DECISION No 31/2020
OF THE EUROPEAN UNION AGENCY
FOR THE COOPERATION OF ENERGY REGULATORS
of 30 November 2020

**ON THE SEE CCR TSO's PROPOSAL FOR THE METHODOLOGY FOR
COST SHARING OF REDISPATCHING AND COUNTERTRADING**

Figure 1: The difference between two considered options for priorities of flows

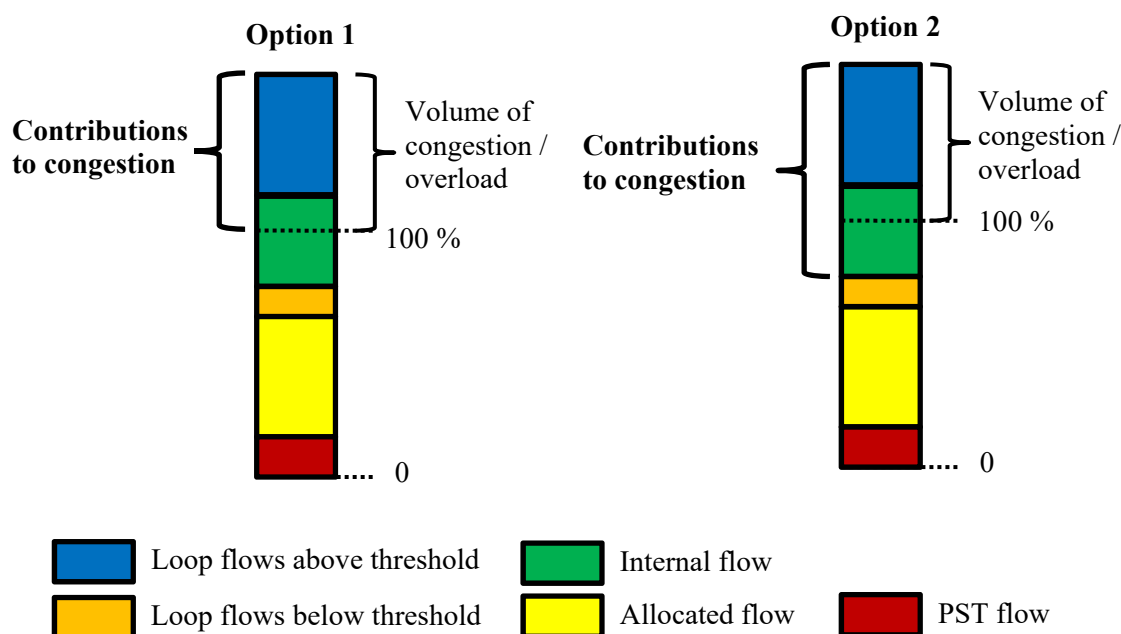
- (121) Option 1 and 2 are presented in the figure below, which shows the stacking of different flow components in relation to the maximum capacity of the network element (denoted with 100%). In Option 1 of this example all loop flows are identified as contributors to congestion, whereas for internal flow only the internal flow which is needed to cover the remaining congestion is identified as contributor to congestion. In Option 2, all loop flows and the whole internal flow are identified as contributors to congestion, however, since their sum is larger than the volume of congestion they are scaled down afterwards to become equal to the volume of congestion (i.e. volume of overload). This scaling does not change the relative shares of loop flows and the internal flow.

- (122) ACER carefully evaluated different arguments from TSOs and regulatory authorities, analysed possible options and performed the simulations of investigated options based on the data for Core CCR. While ACER recognises some validity of arguments of both groups of TSOs and regulatory authorities, it considers that the arguments for Option 1 are stronger in this specific case.

- (127) Article 74(6)(a) of the CACM Regulation requires that the cost sharing methodology needs to provide incentives to manage congestion, including remedial actions and incentives to invest effectively. For the reasons described above, ACER considers that, in case of internal network elements, the main incentives should be put on the TSOs which cause loop flows (e.g. due to their internal congestion problems) and not on the TSOs which host loop flows and face congestions because of these loop flows. Option 1 therefore provides correct incentive to TSOs which cause loop flows to manage their congestion problems and reduce loop flows, whereas for TSOs which host loop flows,

the incentives to invest are needed only in case their internal flows are causing congestion and Option 1 described above is adequate to provide such incentive. Option 2, on the other hand, would define completely wrong incentives, i.e. insufficient incentives to reduce loop flows and unfair incentives to TSOs which host loop flows to invest, despite the true reason for congestion being outside of their responsibility.
